Report on Consultation

Creag Dhubh to Inveraray 275 kV Overhead Line

Reference: LT000194

**August
2022**

Title: Creag Dhubh to Inveraray 275 kV Overhead Line
Figure 2: Baseline Alignment with Deviations

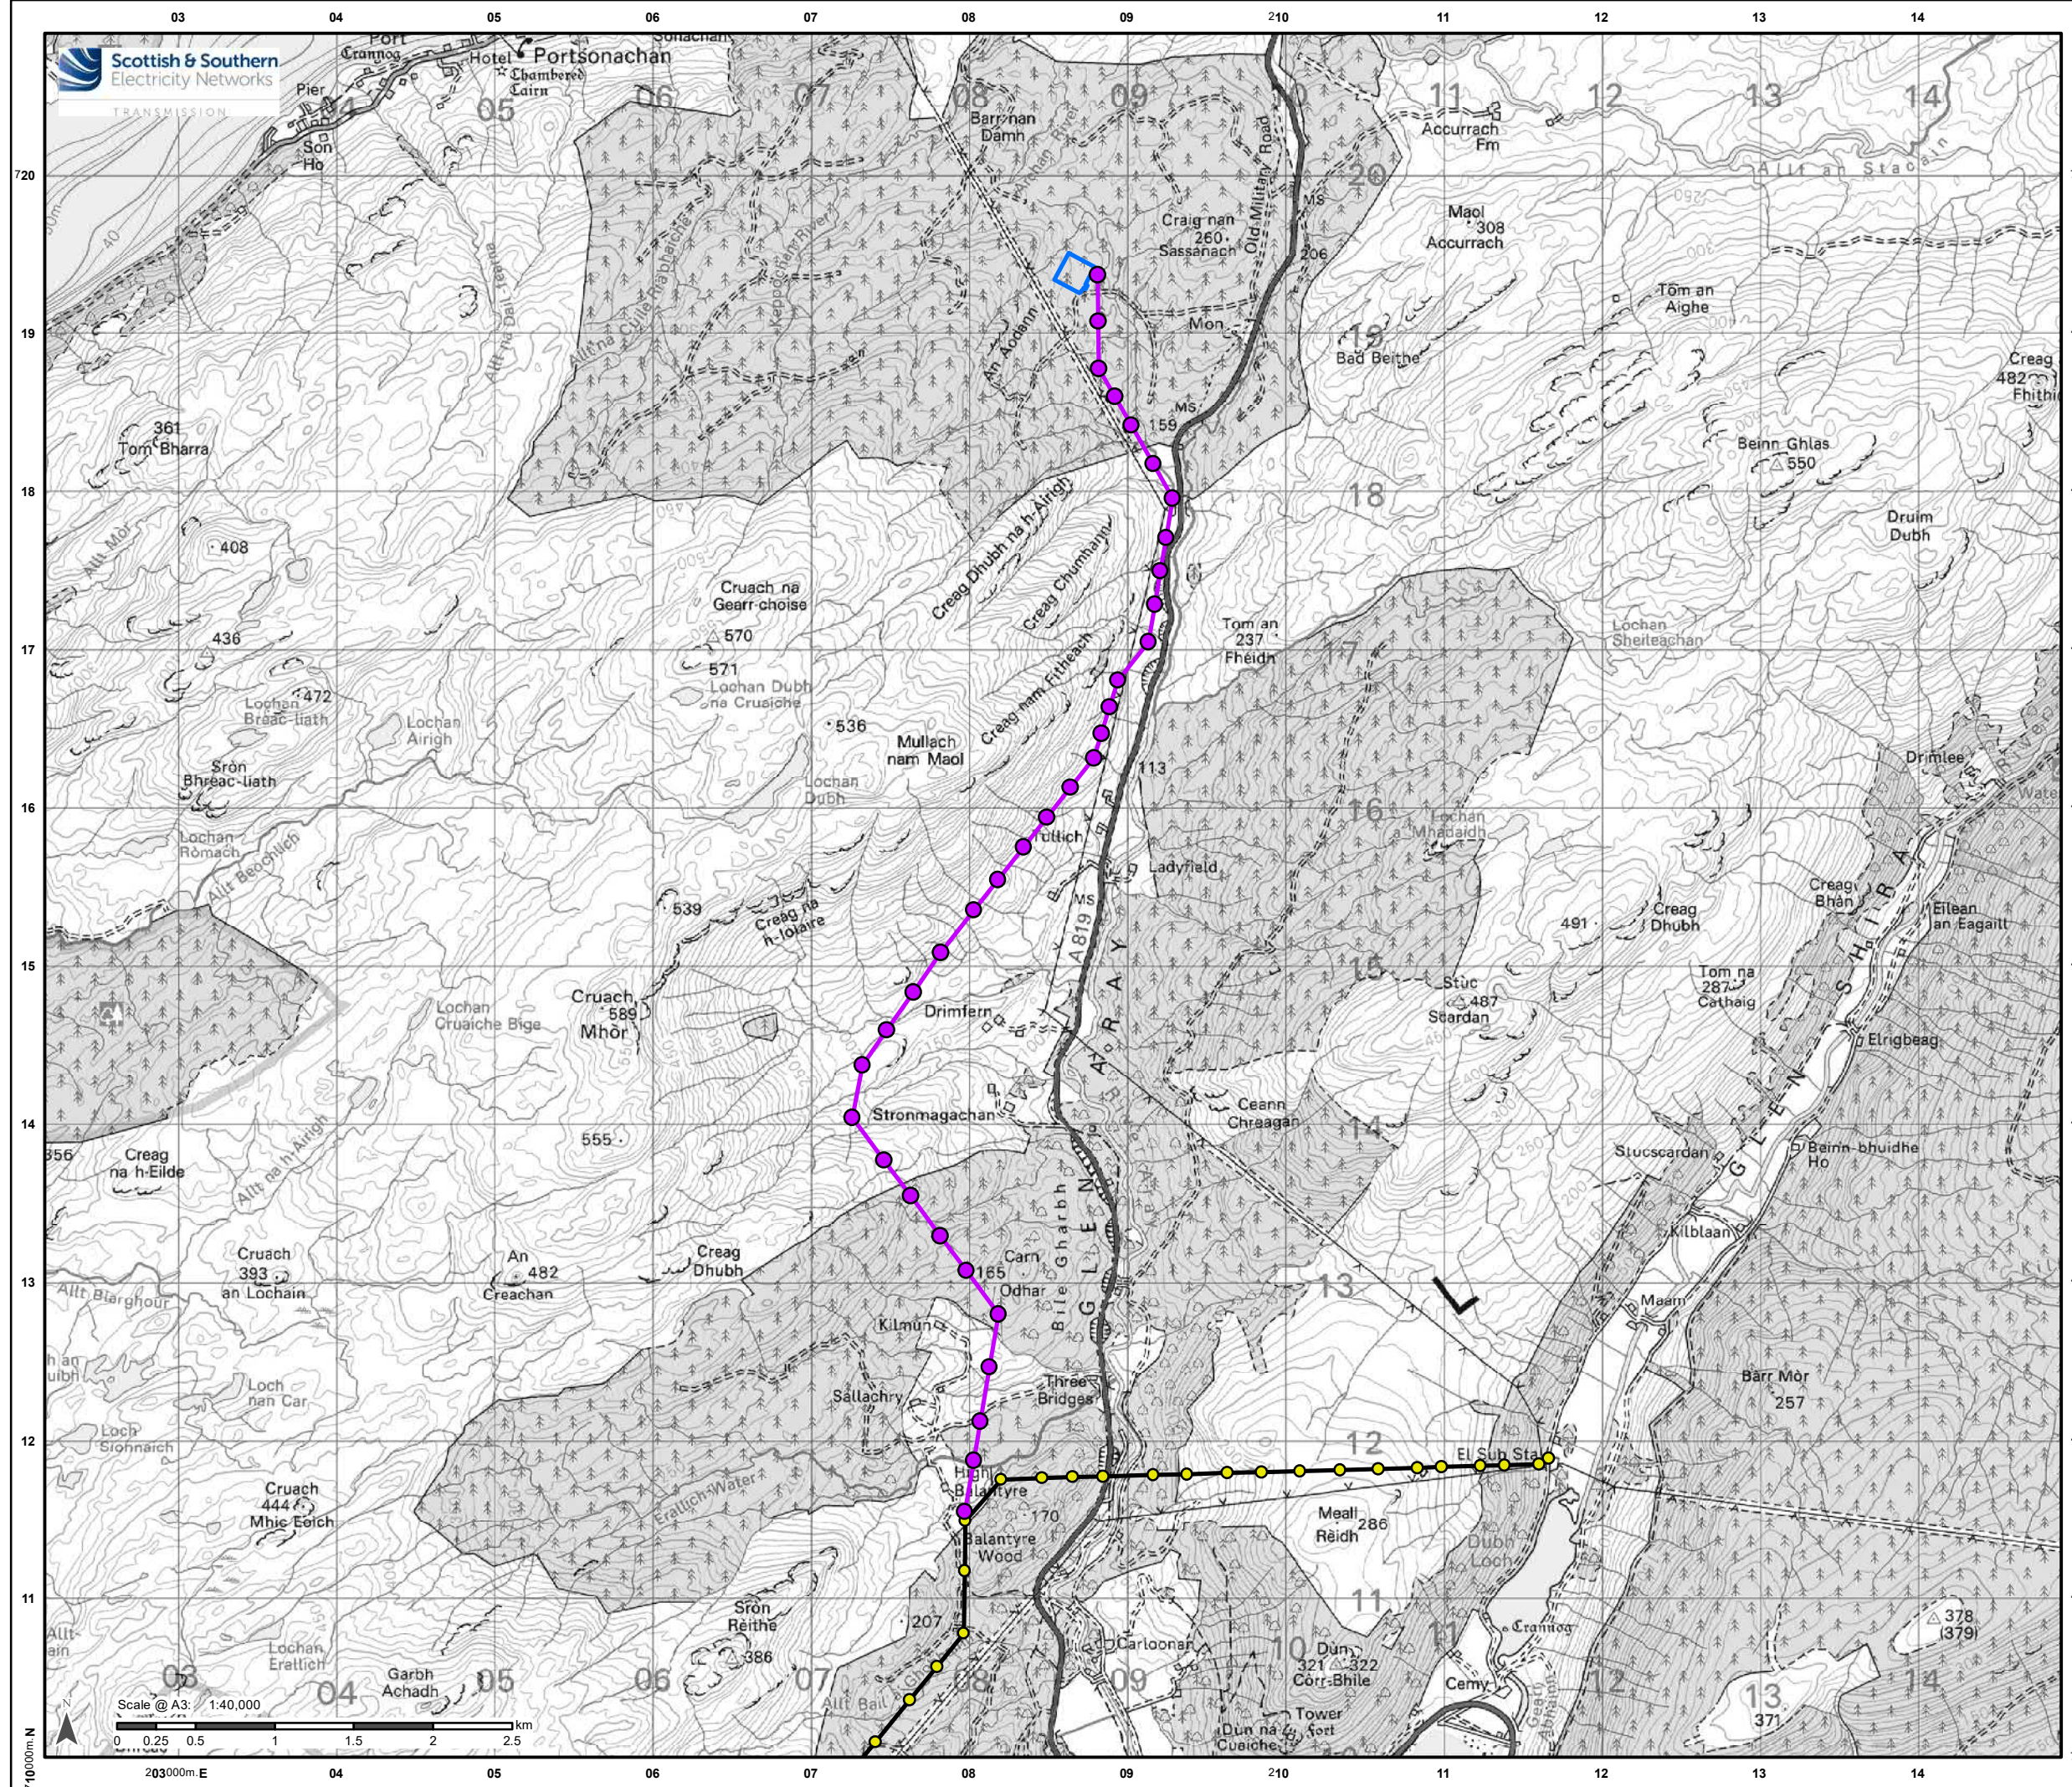
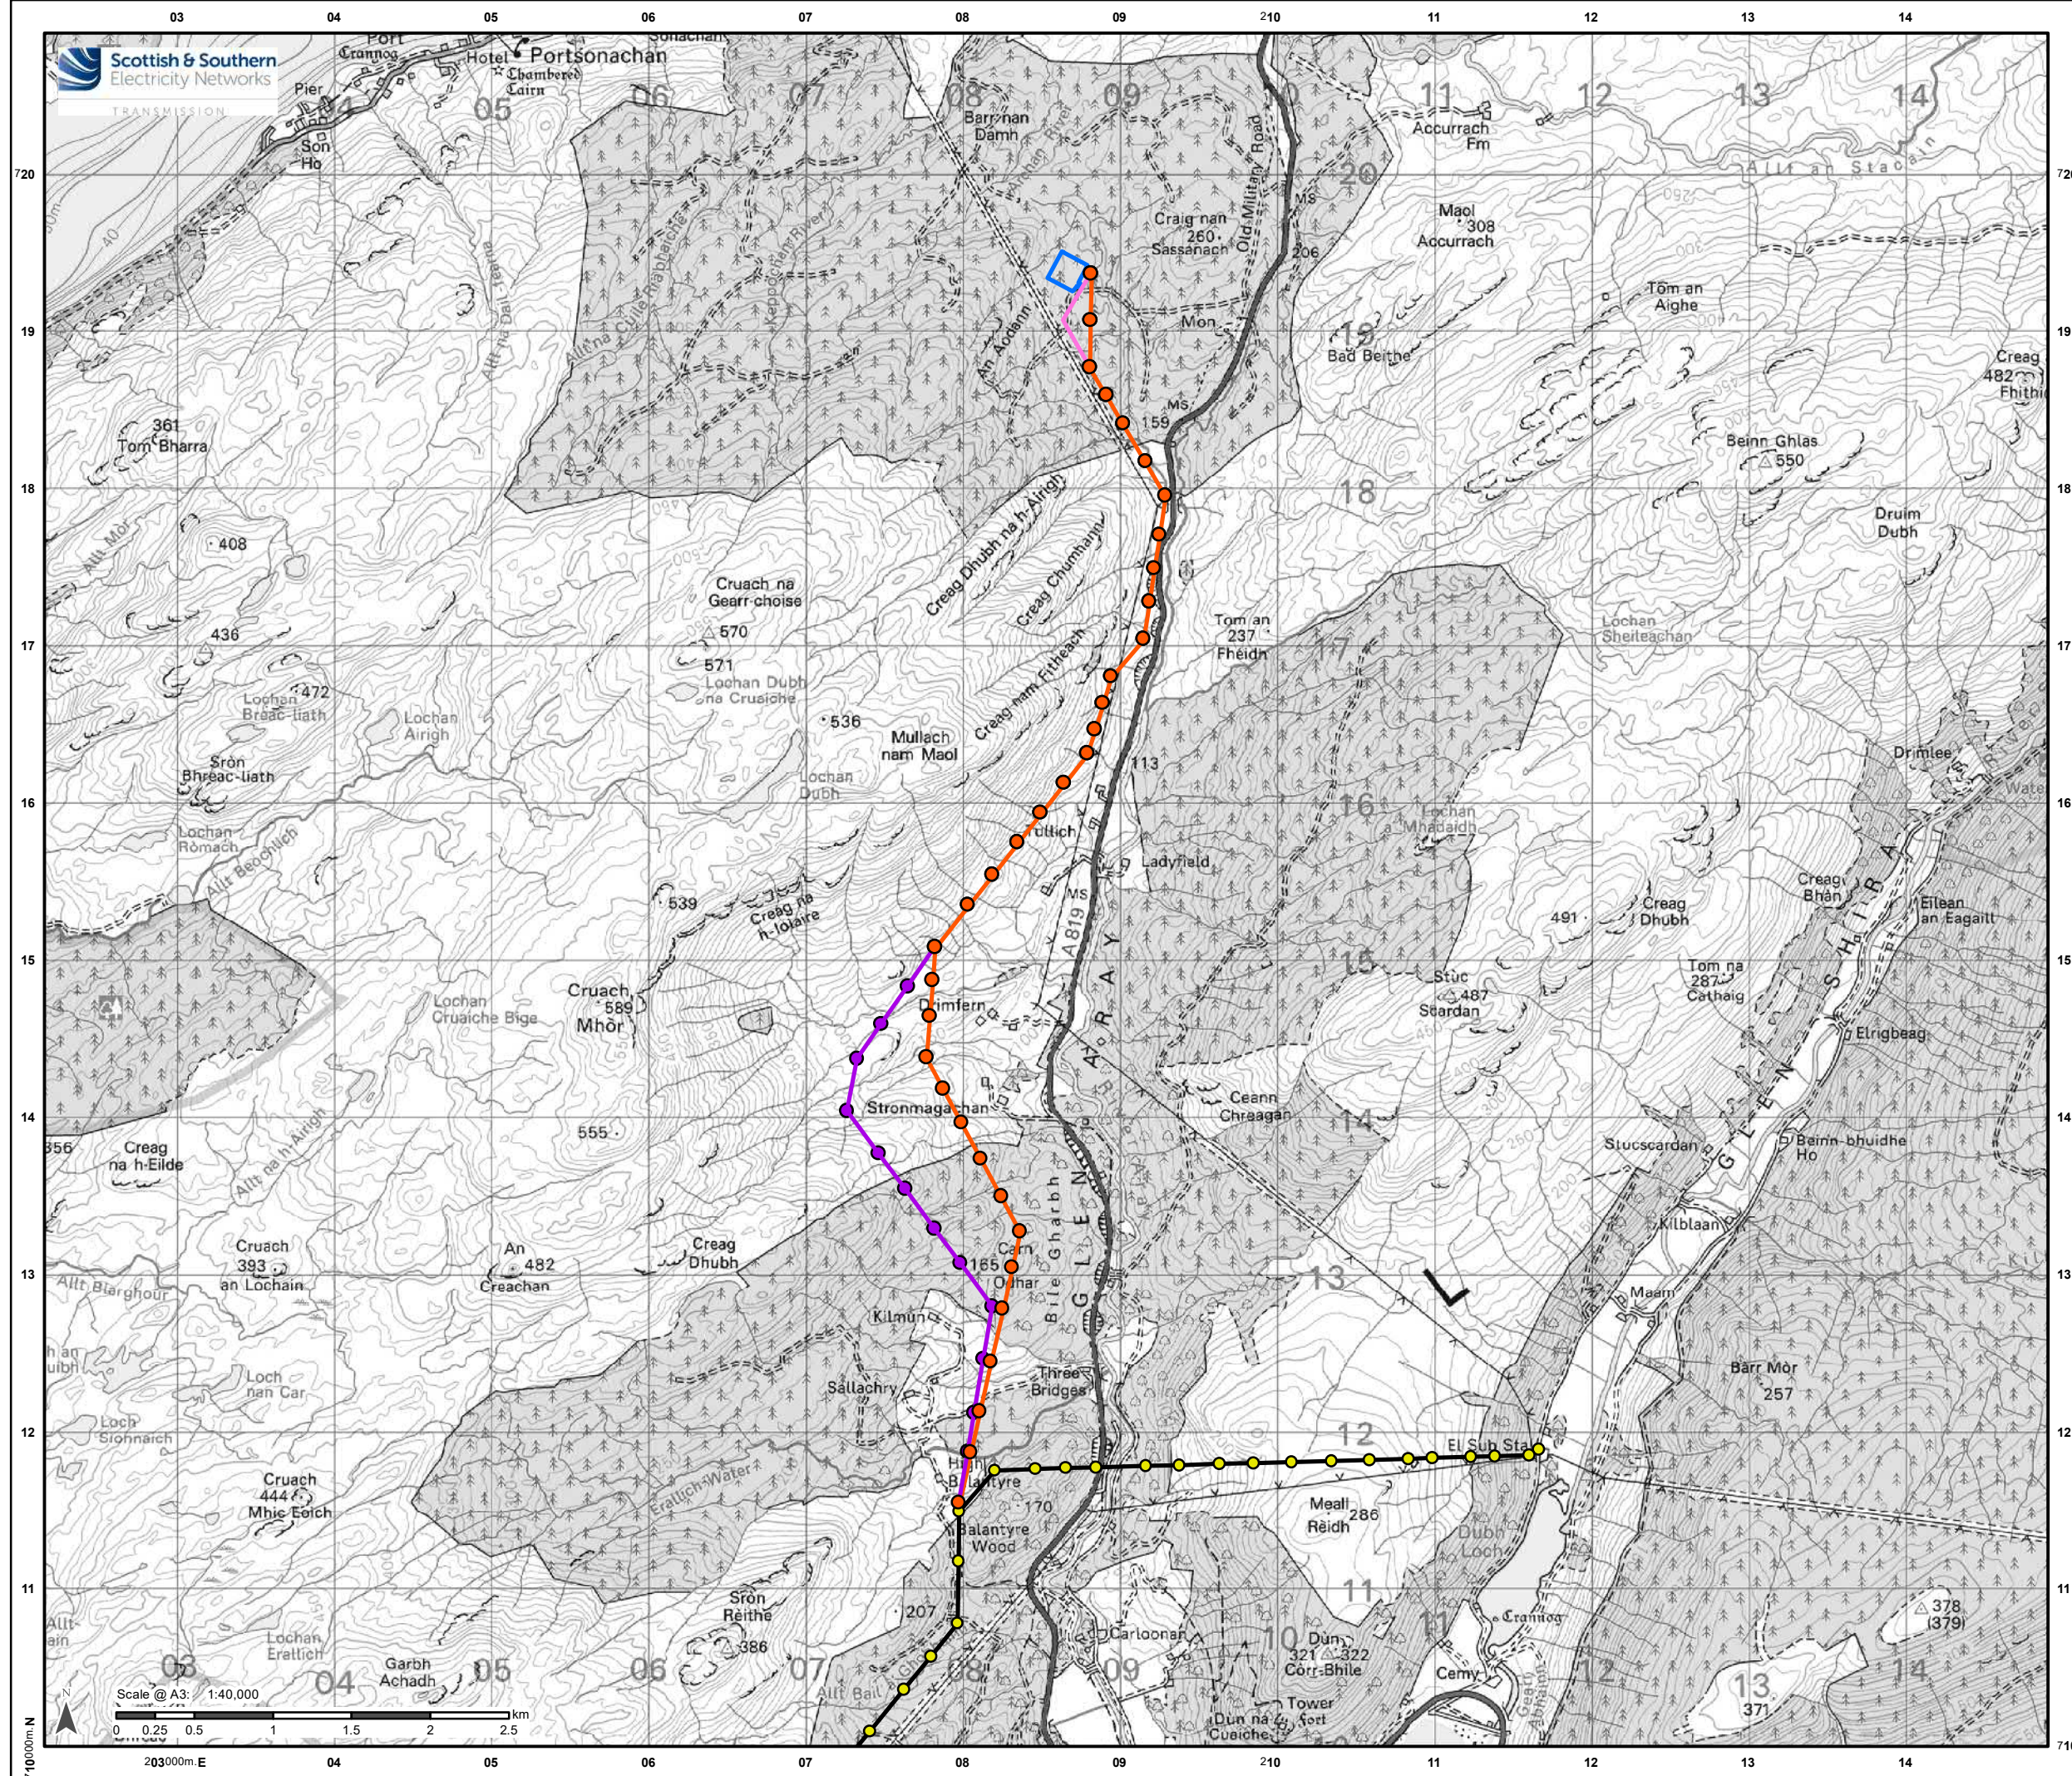
Scottish Forestry	<p>Deviation 1 seems to be a slight improvement reducing impact on ancient woodland and LEPO and so we would not raise any concerns.</p> <p>Deviation 2 which has not been taken forward, does raise an interesting point regarding forestry work in and around powerlines, especially where they converge. The owner may still have a wish for commercial woodland, although a change in woodland type in this area may reduce the need for forest management intervention. Is it the case that the OHPL as it continues to the north west – would be connected to the Creag Dhubh station?</p>	<p>The OHL would connect into the Creag Dhubh substation.</p>
Scottish Water	<p>The LT194 Creag Dhubh to Inveraray 275 kV OHL alignment lies within the River Aray drought management source catchment. A temporary abstraction from the River Aray for drought mitigation is the preferred option for Inveraray WTW, as this watercourse is more resilient to the effects of drought than the Douglas Water. It is therefore more likely to facilitate an abstraction which would meet full demand in a severe drought situation. Nevertheless, the usual environmental protection measures will be sufficient in this area during the proposed works. Scottish Water can keep in touch as work progresses within this area and in the unlikely event of a drought, Scottish Water can let them</p>	<p>The appointed Contractor would be responsible for liaising with Scottish Water pre and post construction. Potential impacts to DWPA's, Scottish Water assets and the River Aray catchment will be assessed in the EIA Report.</p>

Table 3: Statutory and Non-Statutory Responses		
	<p>to be an option which is disappointing. We advise that line visibility is increased where it transits close to eagle eyrie sites (the northern section of Deviation 1 outside of the forestry), measures should be for the life-time of the line so ideally some form of coloured line sheathing or failing this hanging type bird deflectors which are replaced as per line maintenance schedule. Ideally it would be good to see mitigation include positive upland management for eagles in this area.</p> <p>Construction (& potentially operational) mitigation The Alignment is c. 1 km of some eyrie sites and therefore potential for disturbance exists within the breeding season so we advise that works especially the use of helicopters should occur outwith the breeding season (Feb-August) or only within this period if breeding is proved to be unsuccessful within that season.</p>
